# CITY OF ALBUQUERQUE

Re: McDonalds – Coors & Hanover
1501 Coors Blvd NW
Traffic Circulation Layout
Engineer's/Architect's Stamp XX-XX-XX (J11-D037)

Based upon the information provided in your submittal received 01-25-17, the above referenced plan cannot be approved for Building Permit until the following comments are addressed:

CIRCULATION PLAN

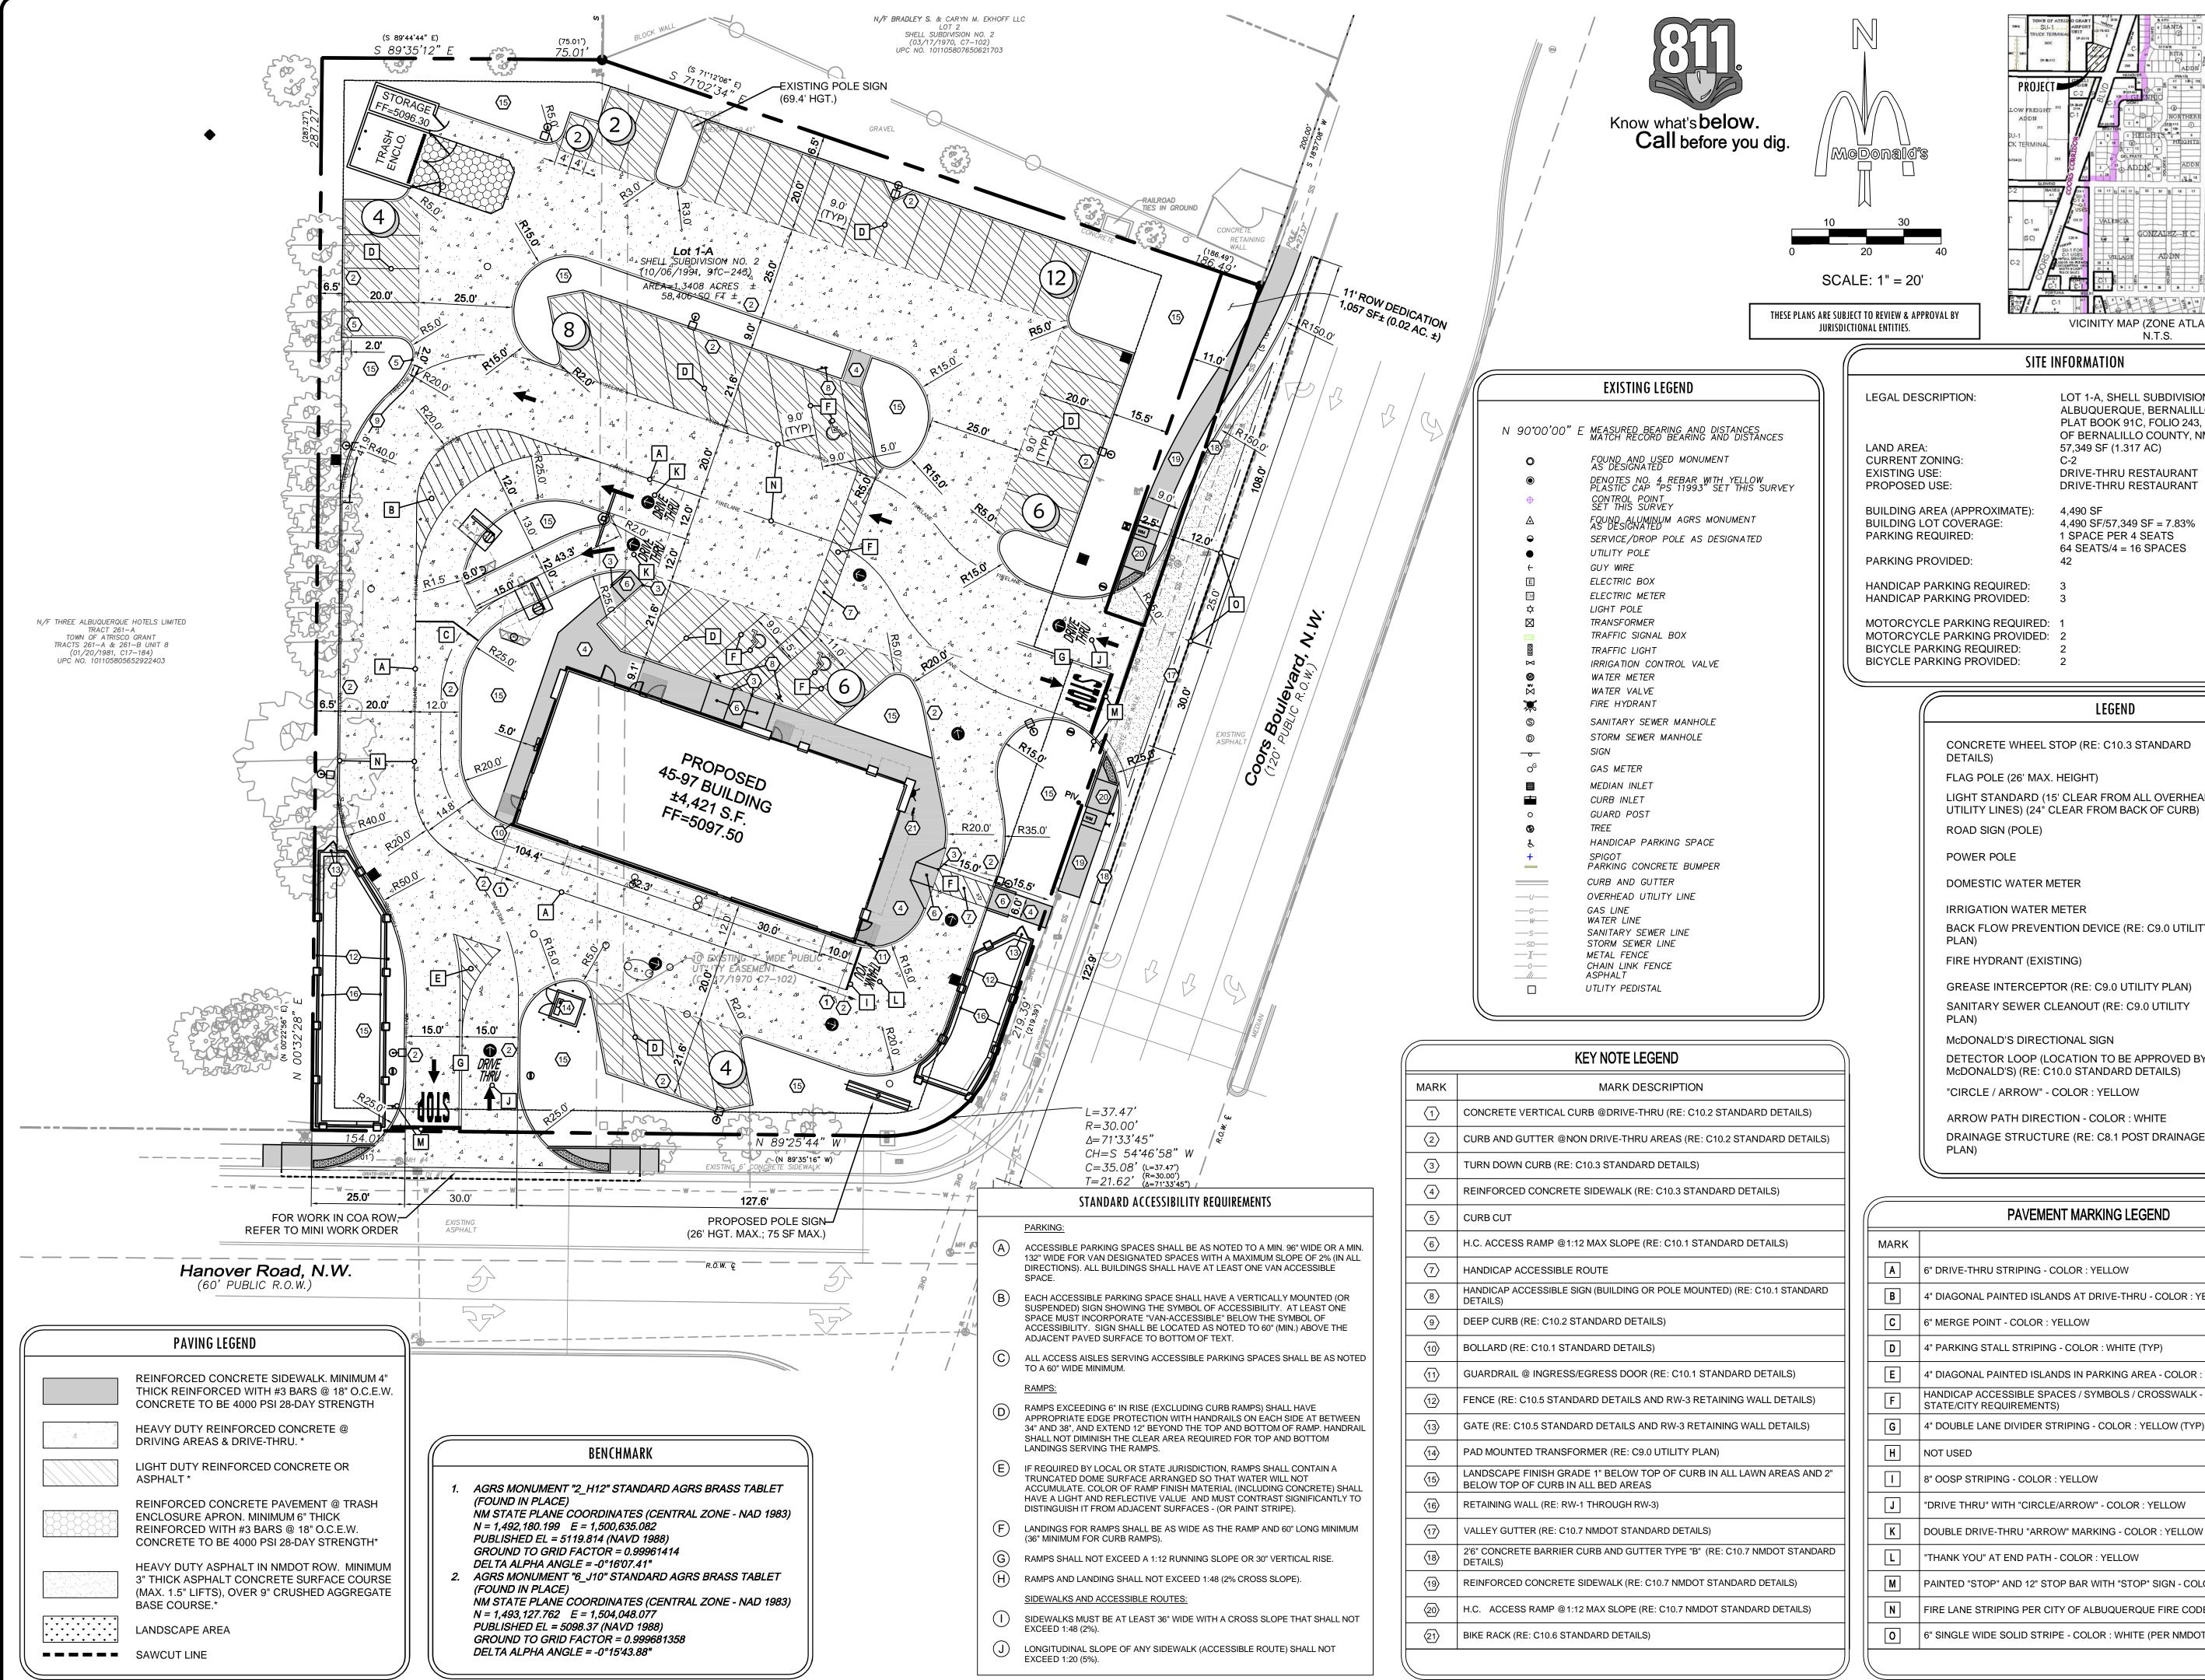
- The traffic circulation layout must be stamped, signed, and dated by an engineer or architect licensed in the state of New Mexico.
- 2. Please provide the angle of the angled parking.

- The ADA accessible parking sign must have the required language per 66-7-352.4C NMSA 1978 "Violators Are Subject to a Fine and/or Towing." Please call out detail and location of HC signs.

- 4. The ADA access aisles shall have the words "NO PARKING" in capital letters, each of which shall be at least one foot high and at least two inches wide, placed at the rear of the parking space so as to be close to where an adjacent vehicle's rear tire would be placed. (66-1-4.1.B NMSA 1978)

- 5. Provide a min 6" or max 8" high concrete barrier curb or other acceptable barrier between handicap parking and the sign in front of the building or move signs to sidewalk. Please call out detail and location of barrier curb.

- One-way vehicular paths require pavement directional signage and a posted "Do Not Enter" sign at the point of egress. Please show detail and location of posted signs.

- 7. Please provide the detail sheet showing the standard details for the site.
- 8. Please provide additional information on the ADA curb ramps off of Hanover. Such as key note like the ones off Coors and clearly identify the radii. Will there be a work order for the ramps?

- Please coordinate with NMDOT for work within their right of way. Provide correspondence showing coordination.
